Submitted with
proposed amendment
at Interview on
1 July 1988

FIG. 5

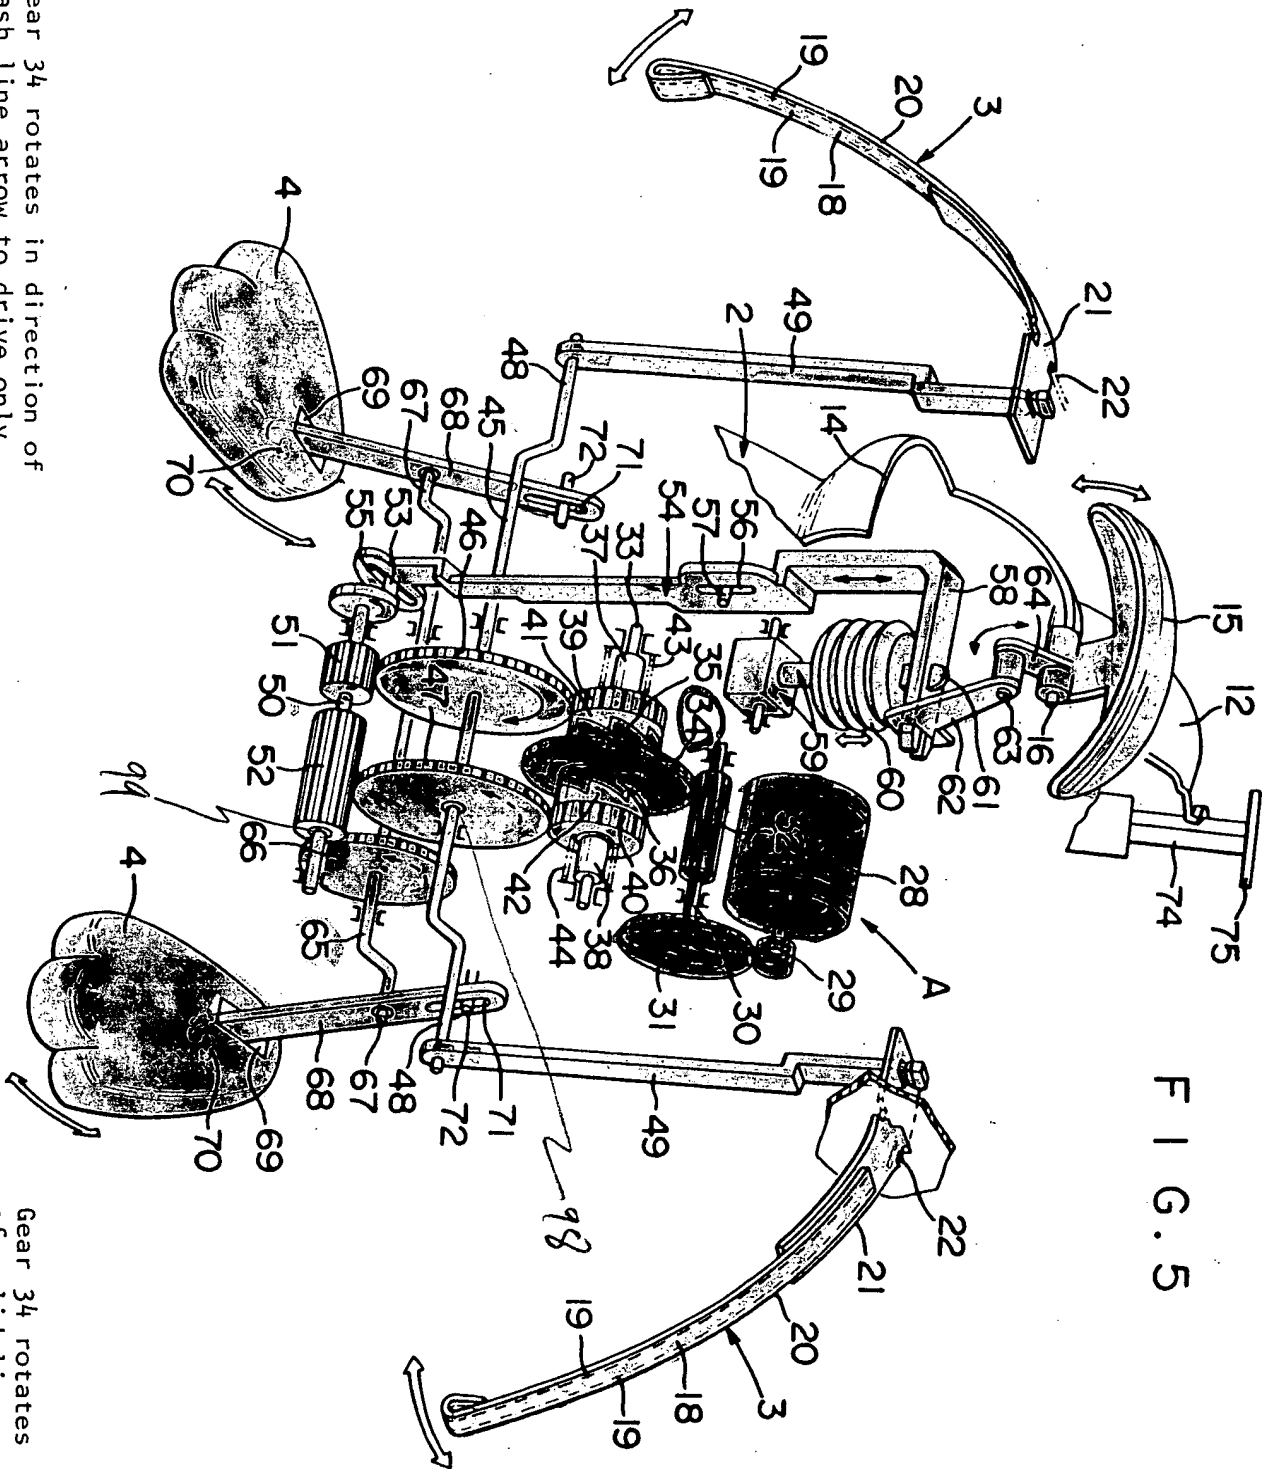
Gear 34 rotates in direction of
dash line arrow to drive only
green leg components.

Gear 34 rotates in direction
of solid line arrow to drive
only blue arm, mouth and sound
components.

FIG. 9

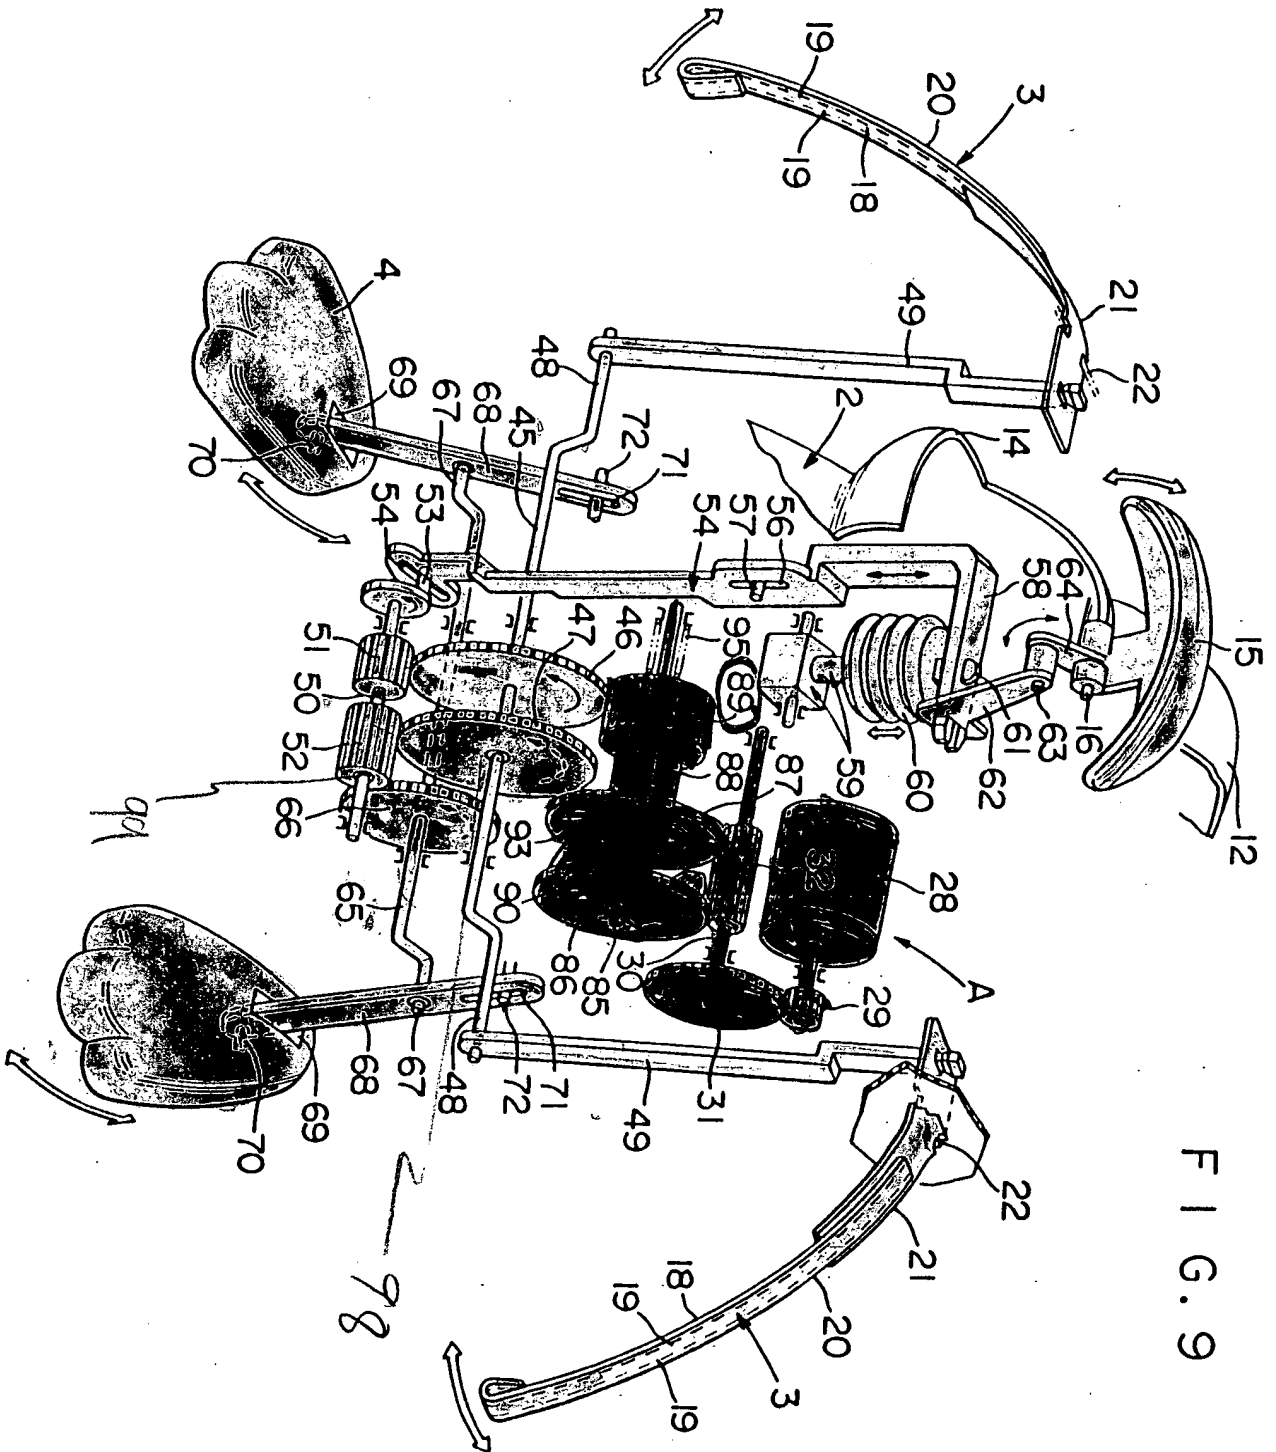
Gear 89 slides to the left to
drive only blue arm, mouth and
sound components.

Gear 89 slides to the right to
drive only green leg components.
